RHODE ISLAND DEPARTMENT OF TRANSPORTATION

Old Tower Hill Rd (Rt 108 - Rt 1)

NOTICE TO PROSPECTIVE BIDDERS

ADDENDUM NO. 2 Prospective bidders and all concerned are hereby notified of the following changes in the Plans, Specifications, Proposal and Distribution of Quantities for this contract. These changes shall be incorporated in the Plans, Specifications, Proposal and Distribution of Quantities, and shall become an integral part of the Contract Documents.

1. Plan Sheet 12

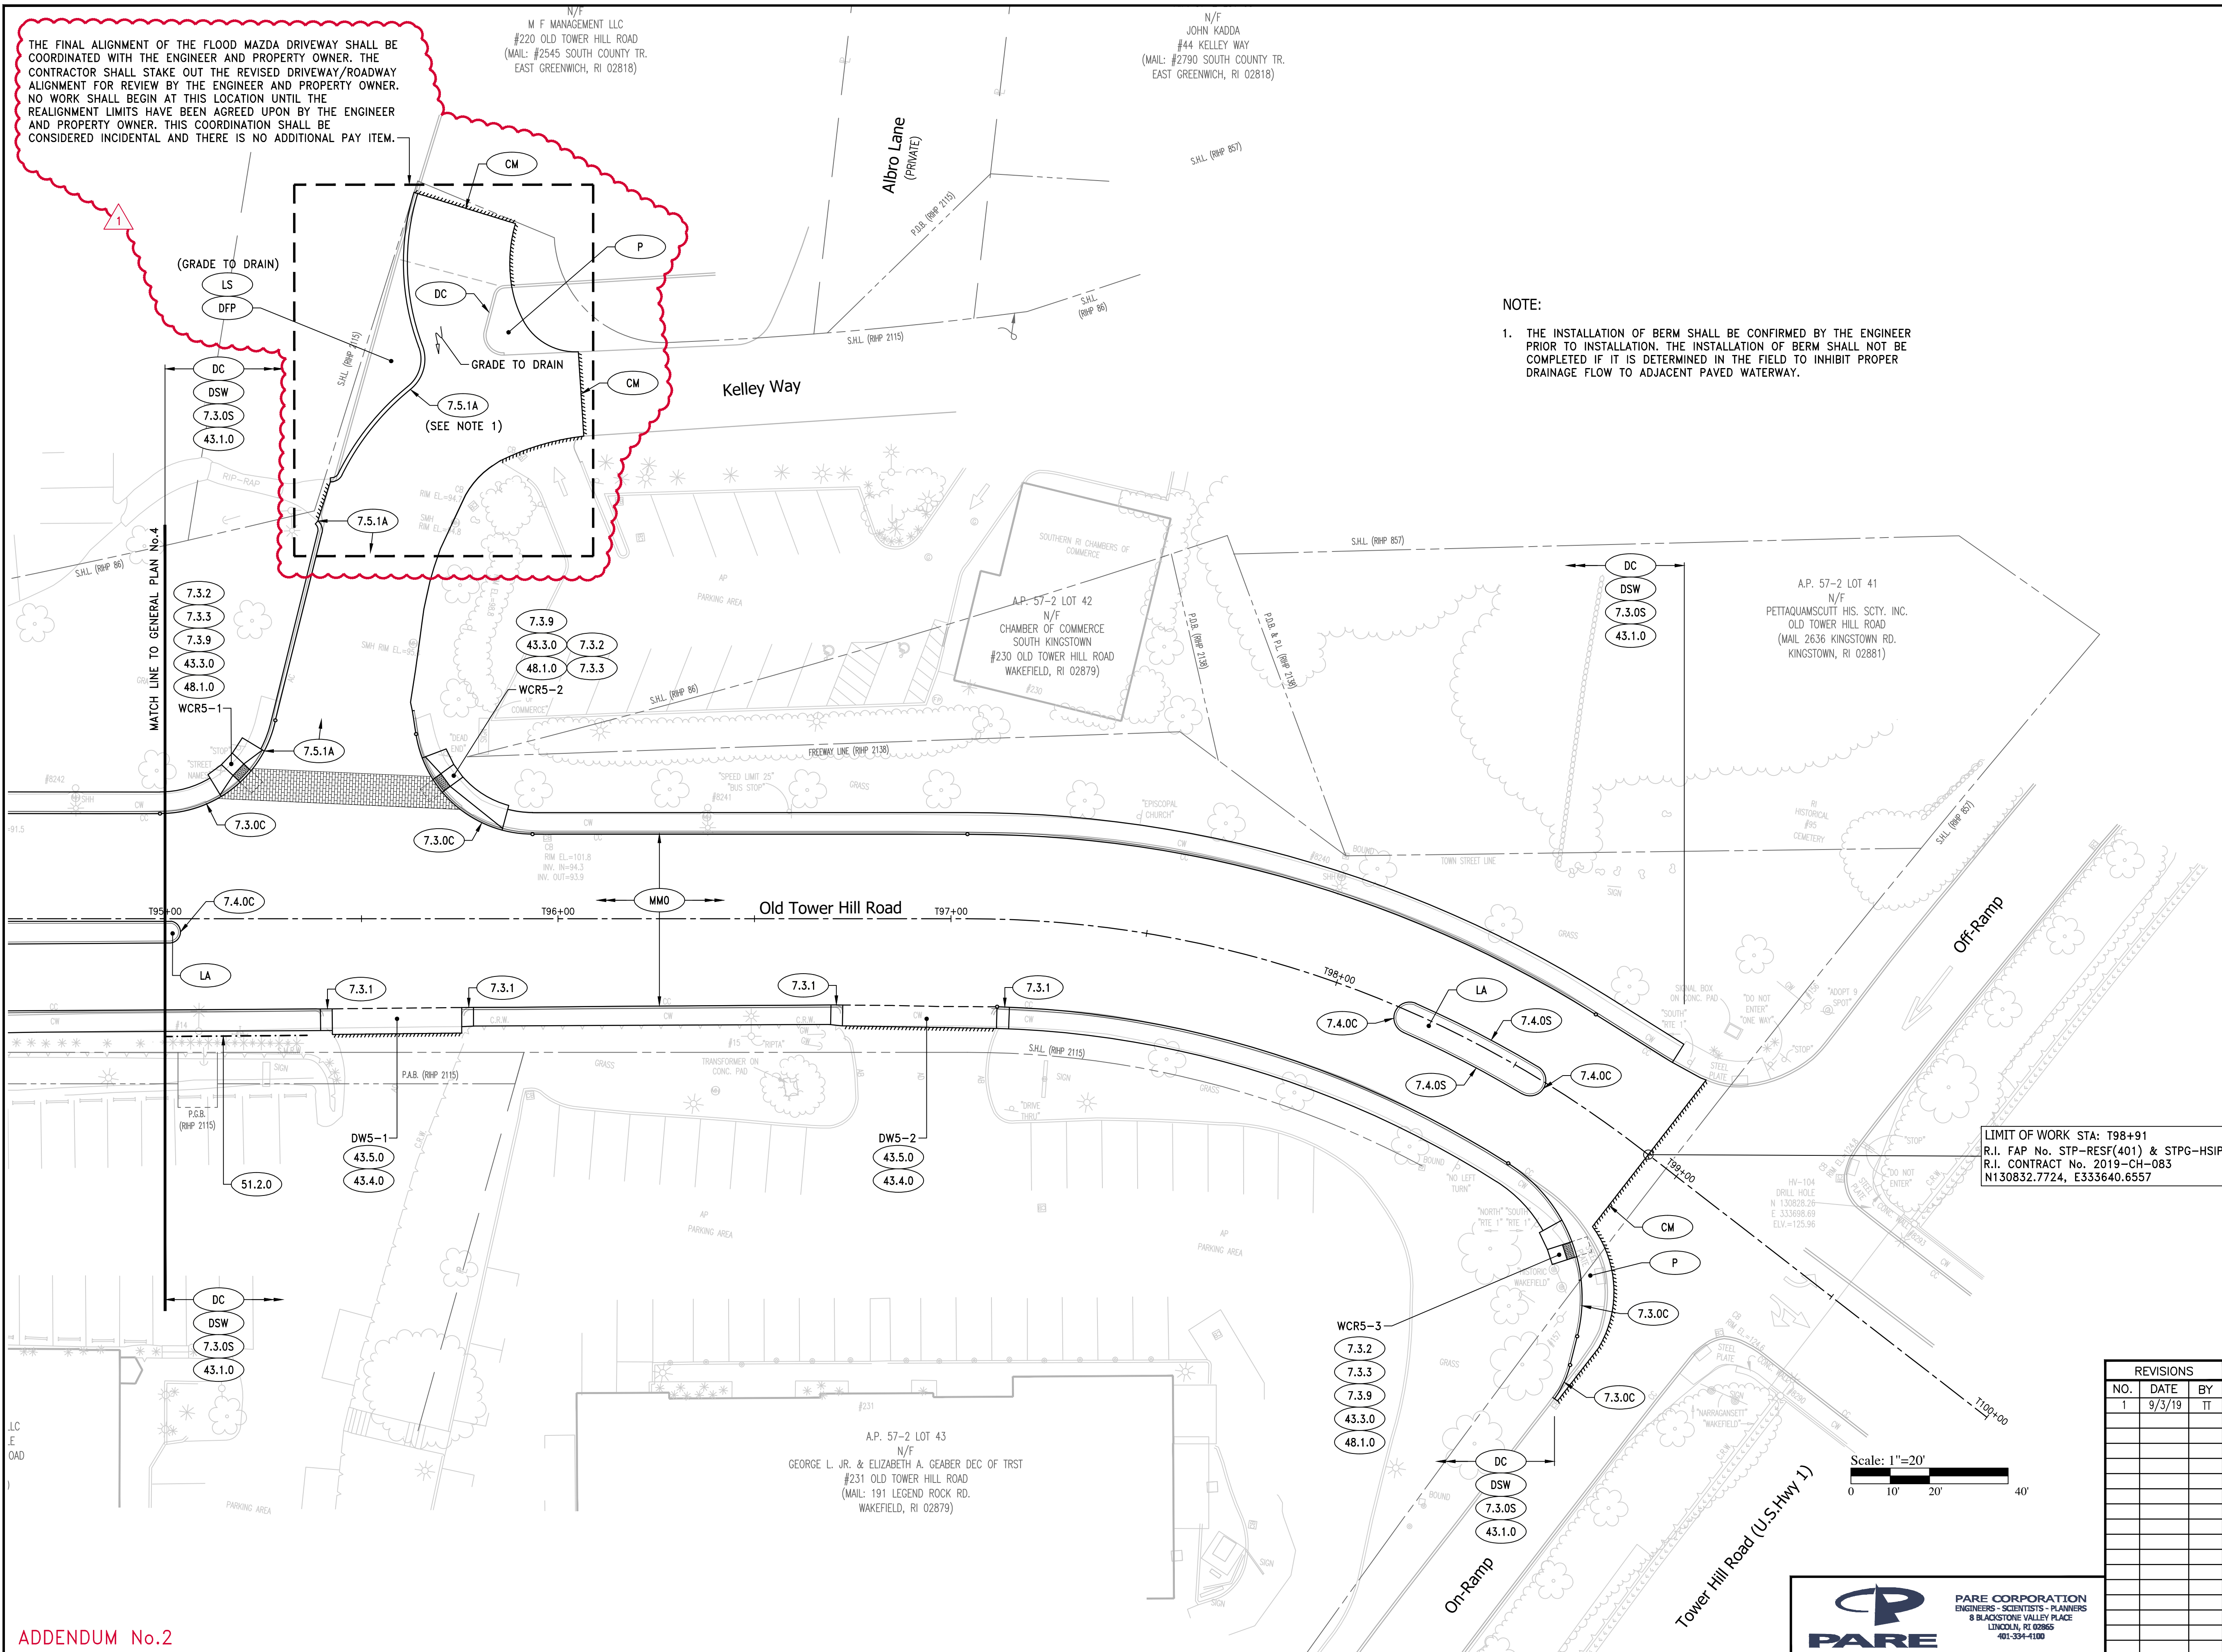
Replace Plan Sheet 12 with Sheet 12(R-1) attached to this Addendum No. 2. A note regarding the work to be performed at the Flood Mazda driveway on Kelley Way has been added.

THE FINAL ALIGNMENT OF THE FLOOD MAZDA DRIVEWAY SHALL BE COORDINATED WITH THE ENGINEER AND PROPERTY OWNER. THE CONTRACTOR SHALL STAKE OUT THE REVISED DRIVEWAY/ROADWAY ALIGNMENT FOR REVIEW BY THE ENGINEER AND PROPERTY OWNER. NO WORK SHALL BEGIN AT THIS LOCATION UNTIL THE REALIGNMENT LIMITS HAVE BEEN AGREED UPON BY THE ENGINEER AND PROPERTY OWNER. THIS COORDINATION SHALL BE CONSIDERED INCIDENTAL AND THERE IS NO ADDITIONAL PAY ITEM.
